APPLICATION FOR MODIFICATION OF CONCEPT PLAN APPROVAL MP05-0083 PURSUANT TO SECTION 75W OF ENVIRONMENTAL PLANNING AND ASSESSMENT ACT 1979.

Land: Lot 22 in DP 1070182 and Lots 497 and 498 in DP 227298 Pacific Highway and Pine Crescent Sandy Beach, Coffs Harbour.

We seek to amend that concept approval such that it allows the proposed laneways to be removed from the concept subdivision layout. This could be achieved by including the amended concept plan ADW Johnson Plan Ref 239312 DA003-D-PLAN OF PROPOSED AMENDMENT TO CONCEPT PLAN 05-0083 dated 02/03/2017 as schedule 4. Refer to **Appendix B**.

APPROVED CONCEPT PLAN

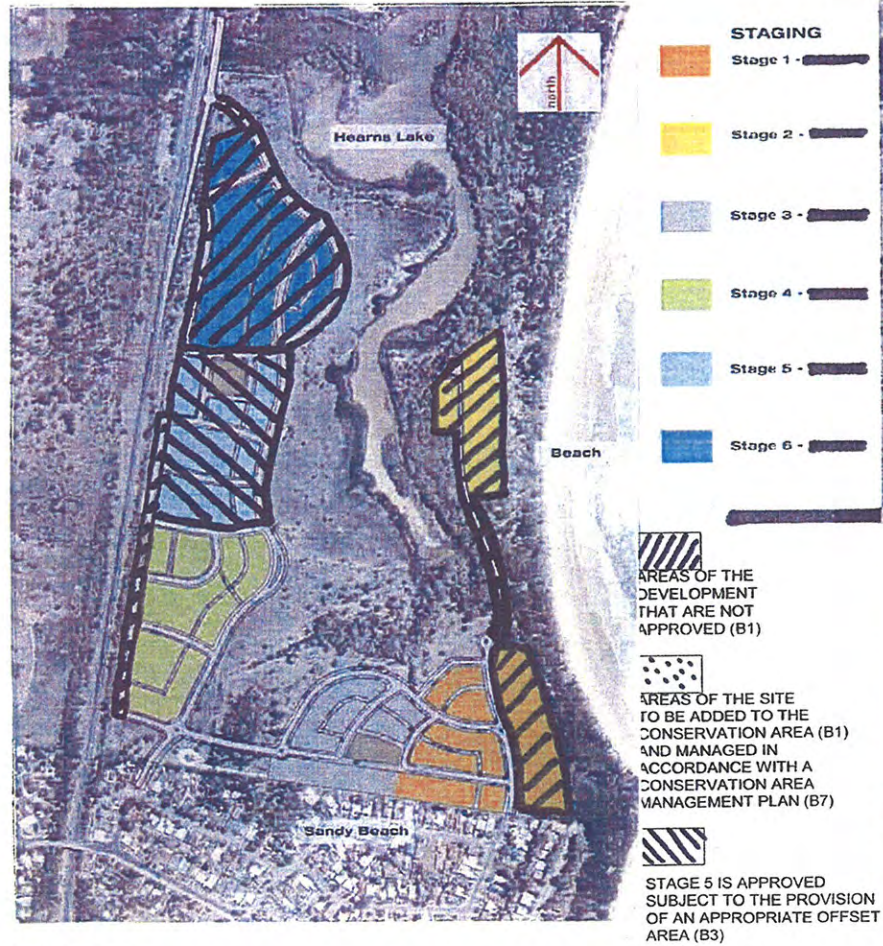
Condition B1 confirms that part Stage 1, Stage 2 and Stage 6 were not approved and we have deleted these from the attached version of the concept plan. The direct connection to the Pacific Highway in the North West corner of the site (Refer Condition B4) was also not approved and has been deleted.

Condition B2 requires that no roads, acoustic barrier walls or lots are to encroach into the 20 metre wide scenic protection zoned land that runs parallel to the Pacific Highway. We have amended the concept plan accordingly.

drawing title:
**PLAN OF PROPOSED
AMENDMENT
TO CONCEPT
APPROVAL 05-0083**

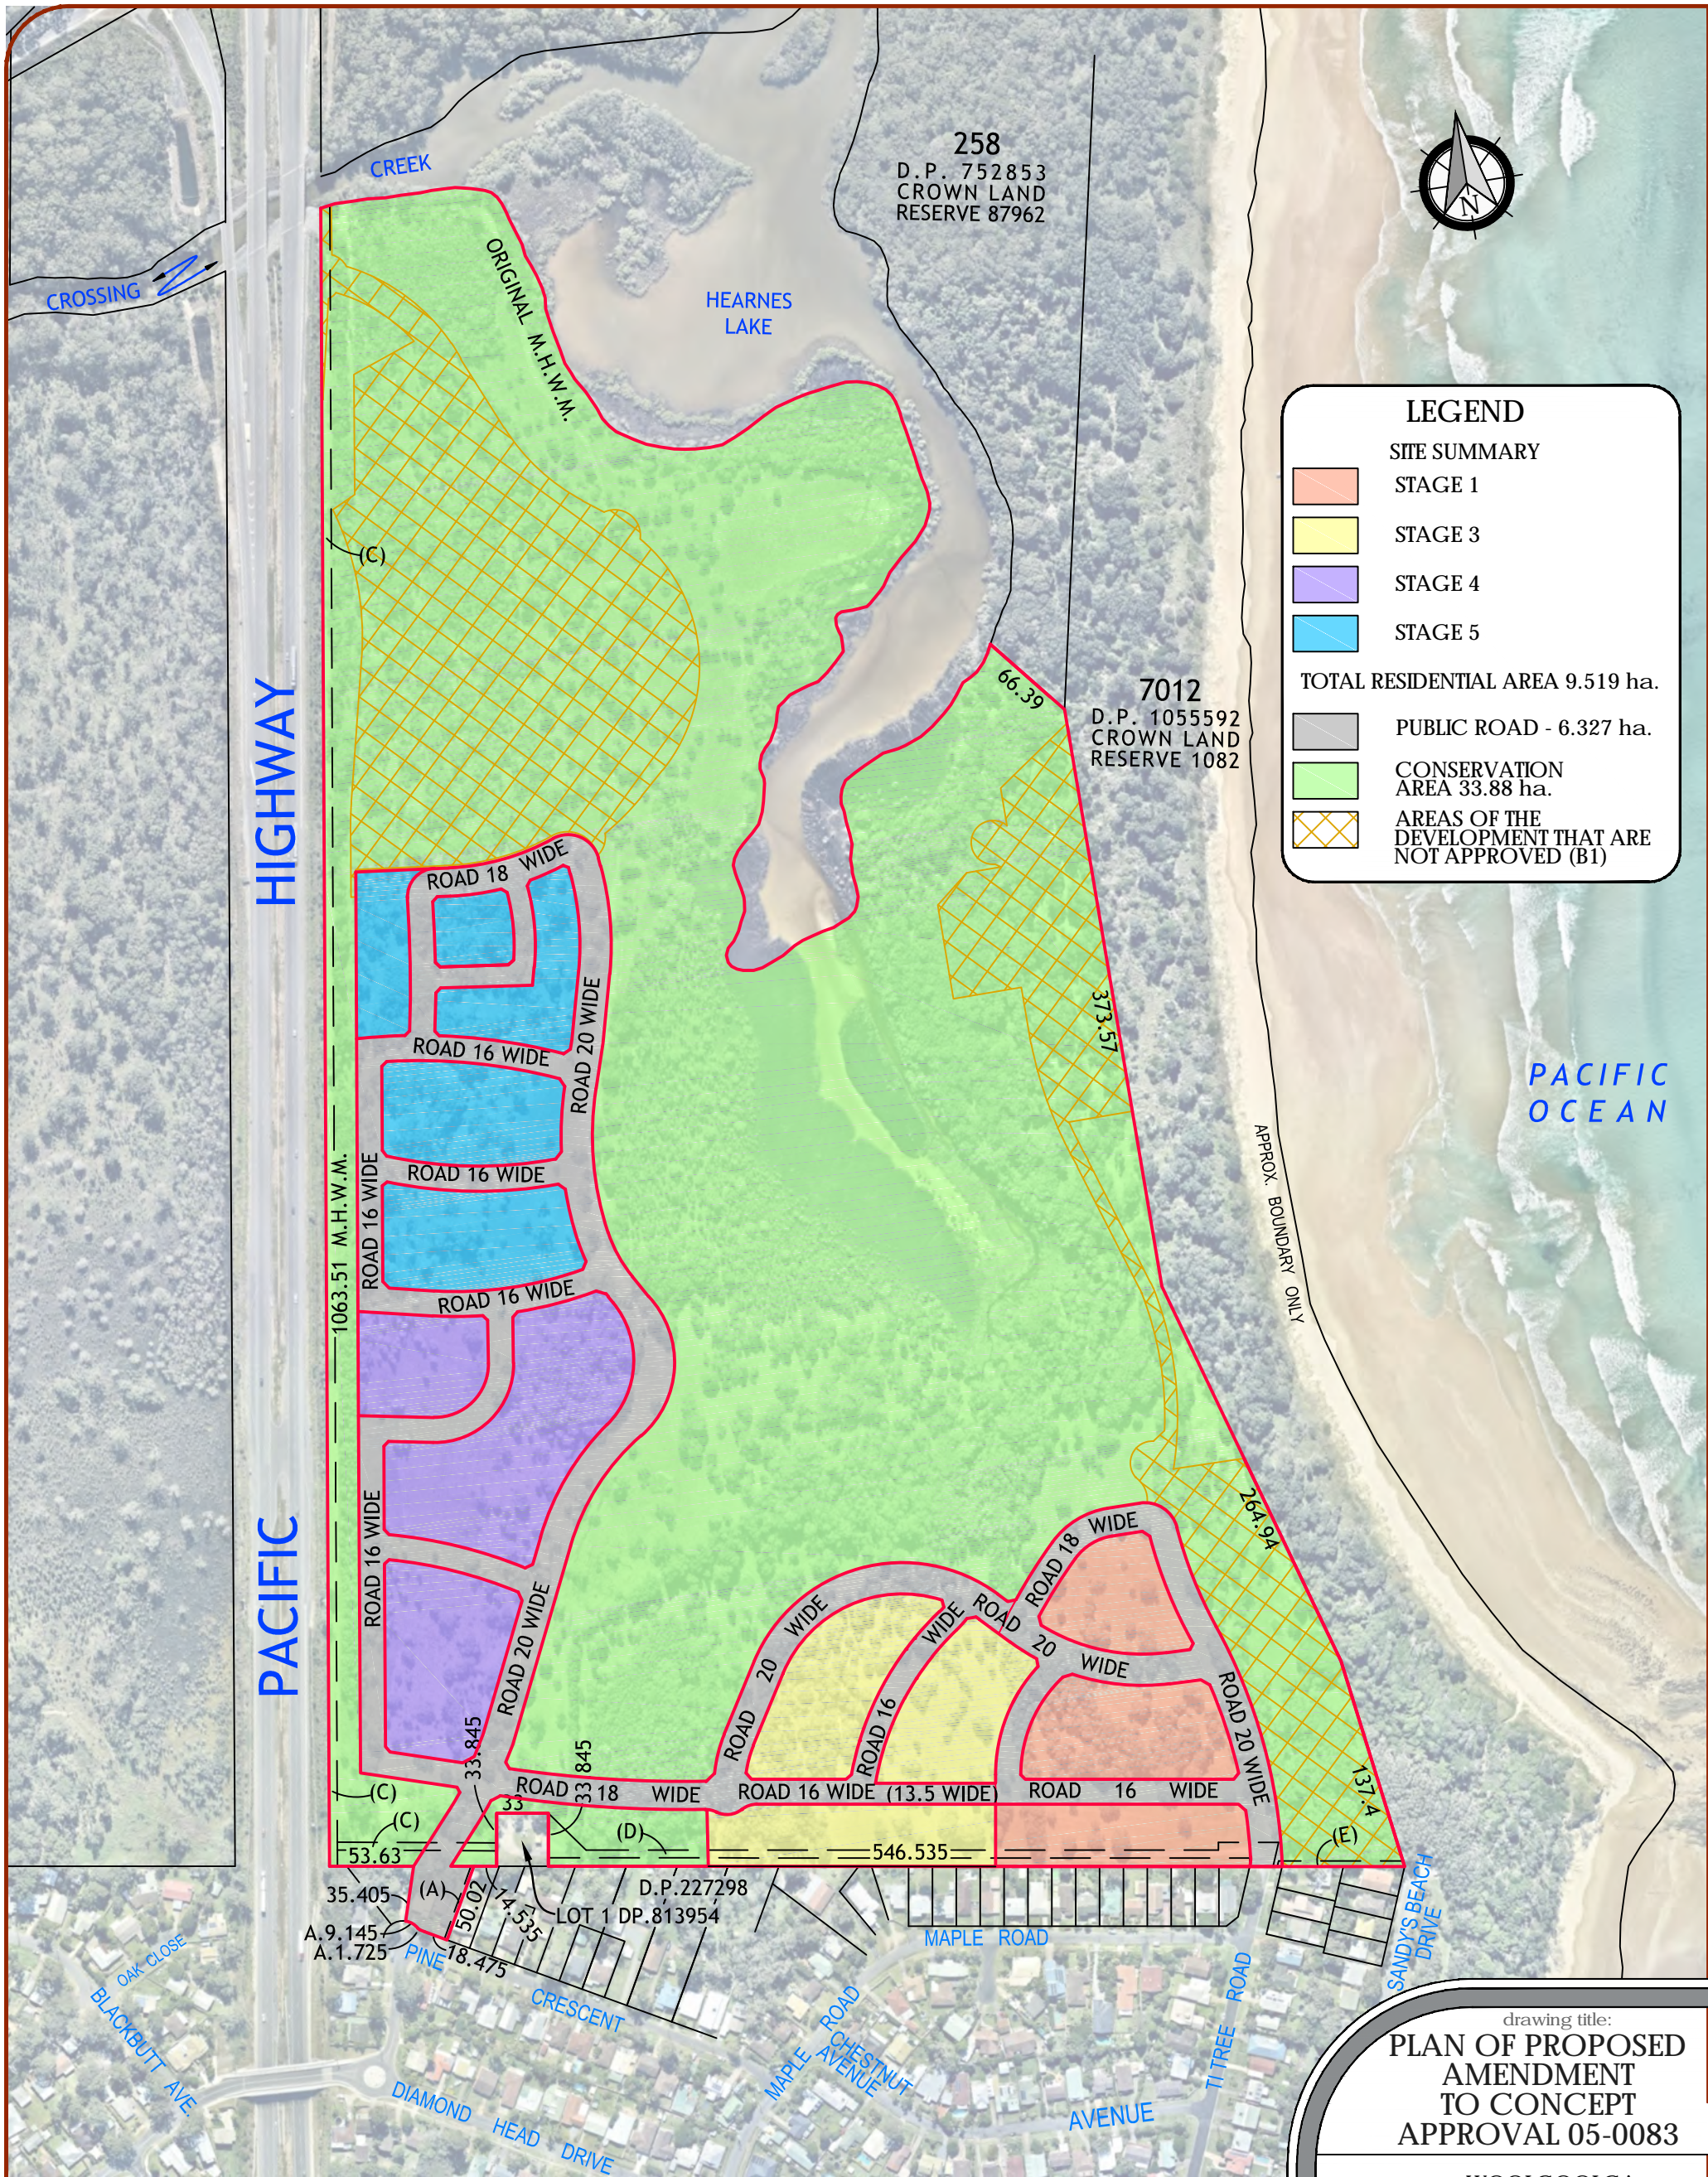
Note 2: the modifications as described in this schedule have been reflected in the Amended Concept Plan ADW Johnson Plan Ref 239312 DA003-D-PLAN OF PROPOSED AMENDMENT TO CONCEPT PLAN 05-0083 dated 02/03/2017 included as Schedule 4.

Deletion of the laneways would result in two building types referred to in the Sandy Beach North Coffs Harbour Design Guidelines becoming redundant. Condition A1 c) is to be amended as follows:

c) Indicative architectural concepts for ~~six~~ **four** building types.

drawing title:
PLAN OF LAYOUT
COMPARISONS ON
DEVELOPMENT

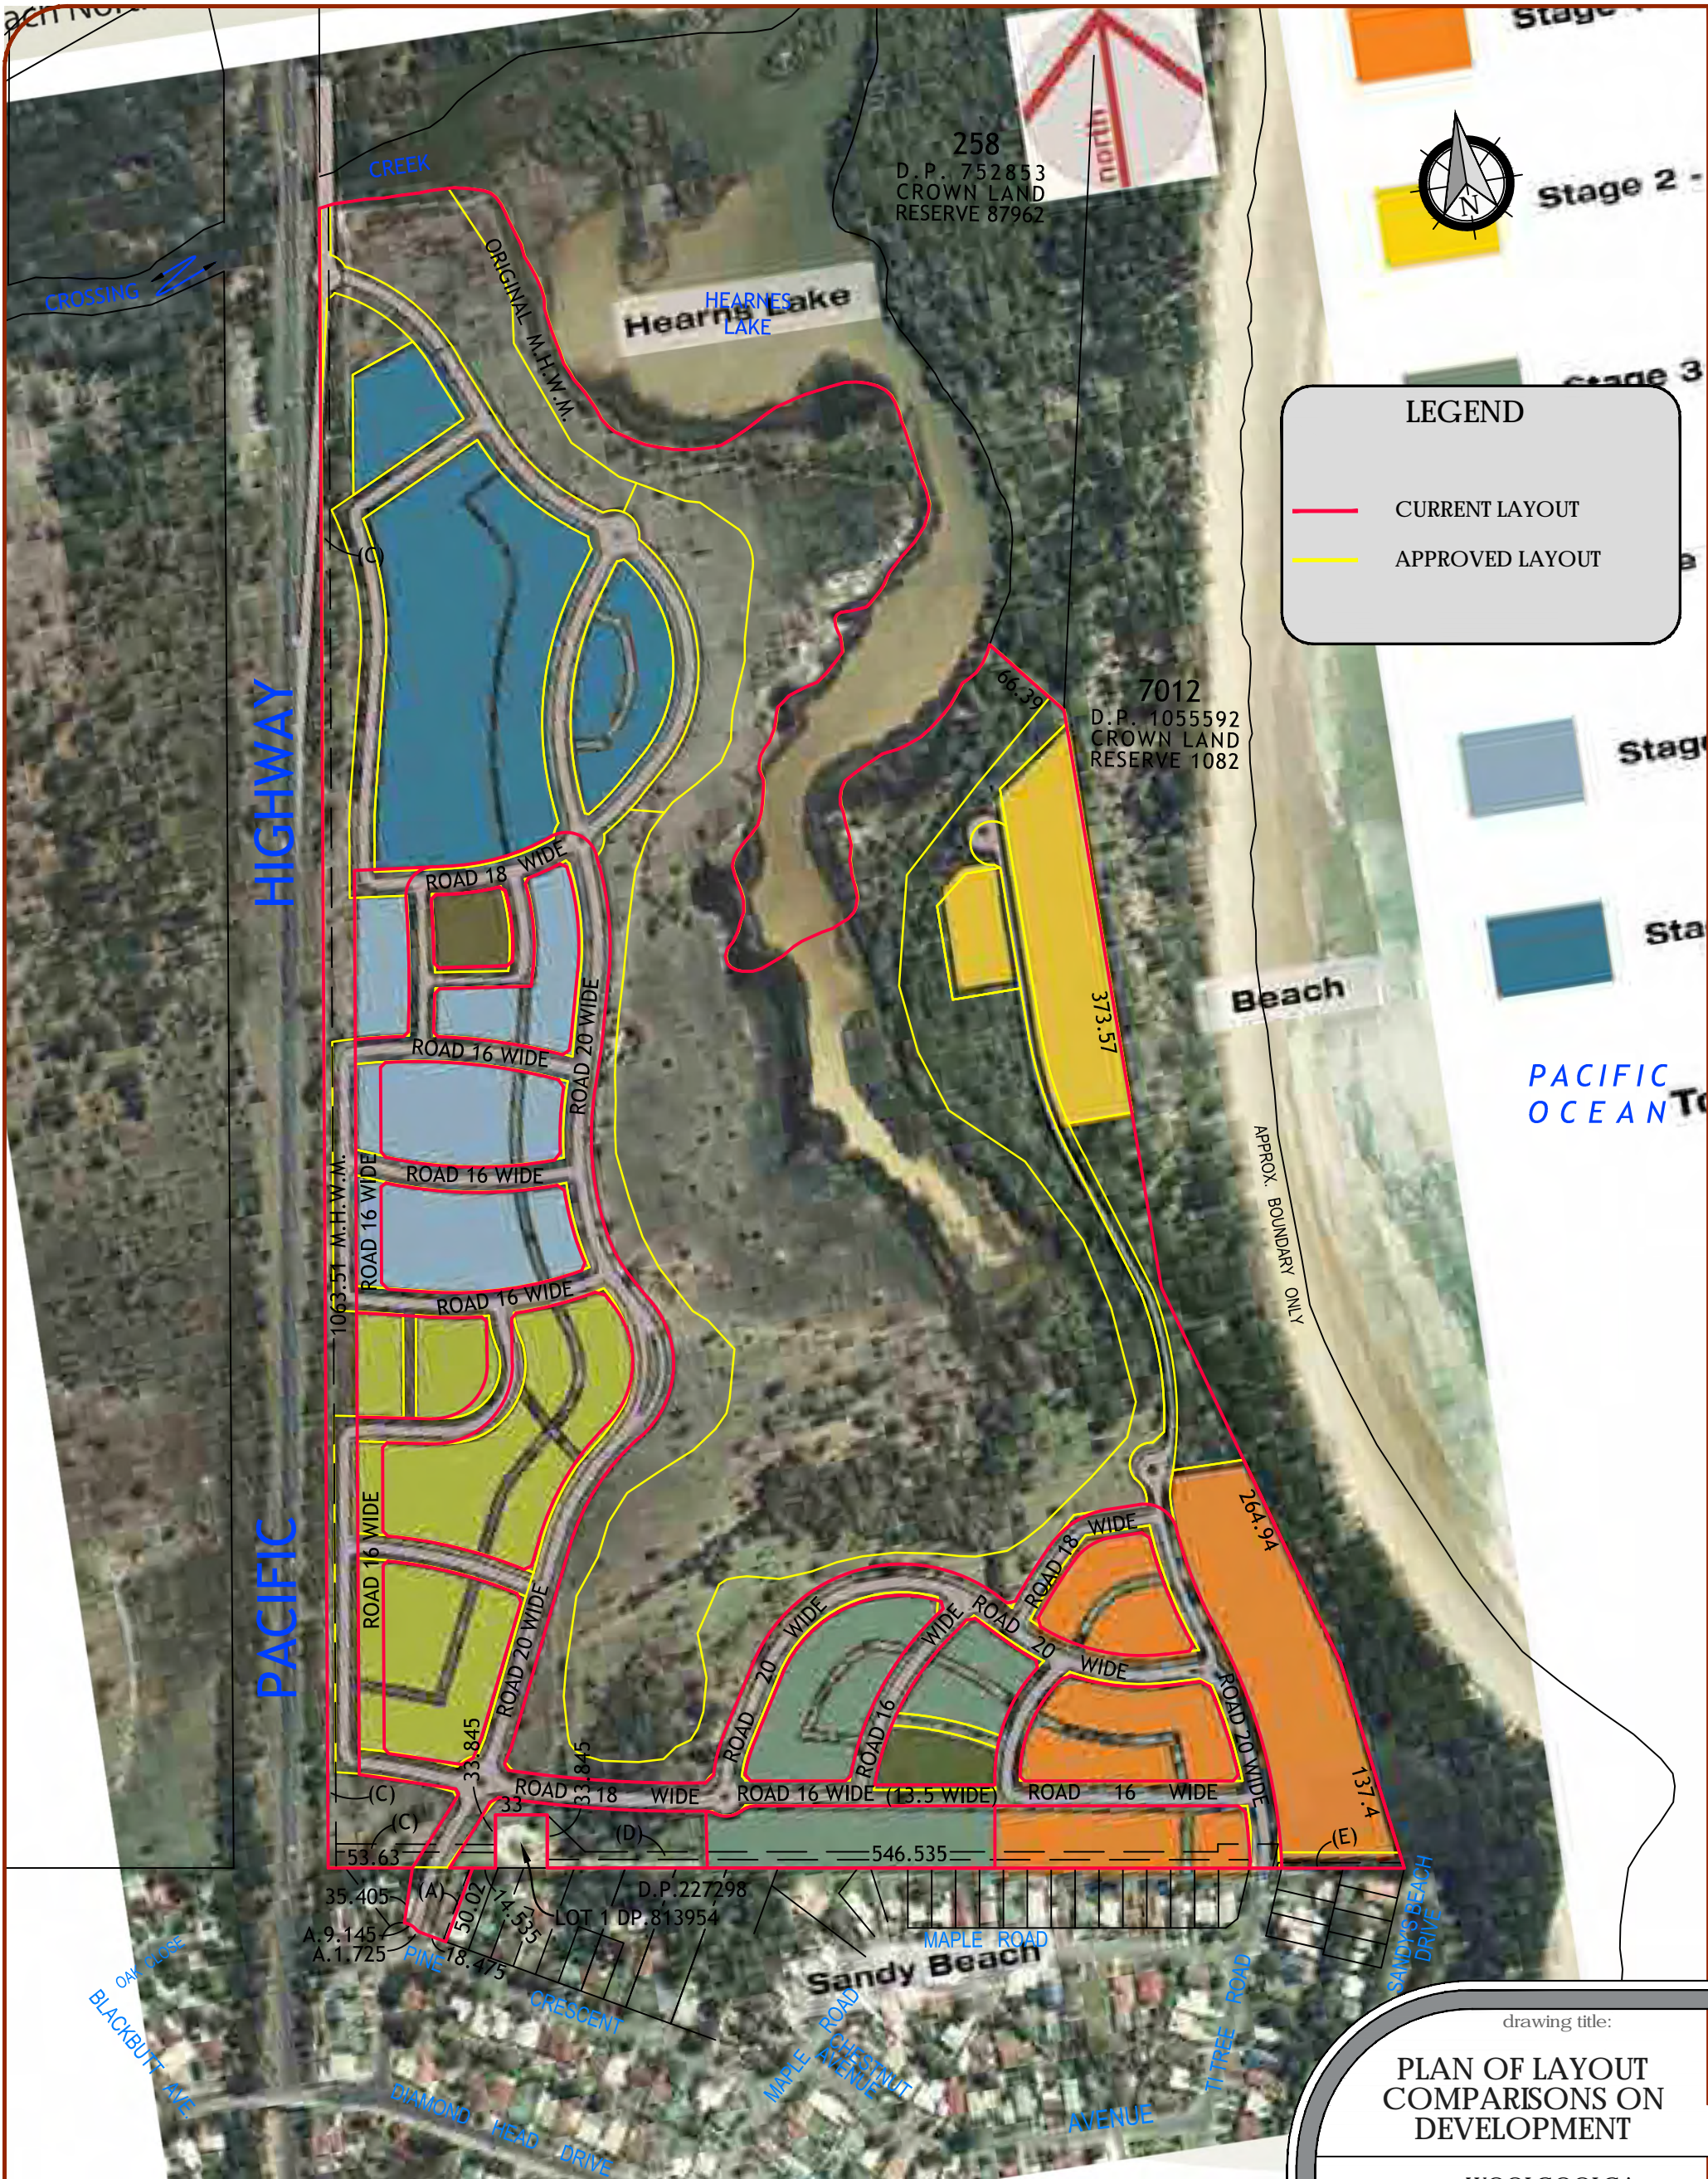
An overlay of the approved concept plan and the proposed amendment to the concept plan are included as **Appendix C**. Refer to PLAN OF LAYOUT COMPARISON OF DEVELOPMENT REFERENCE 239312/DA004A.
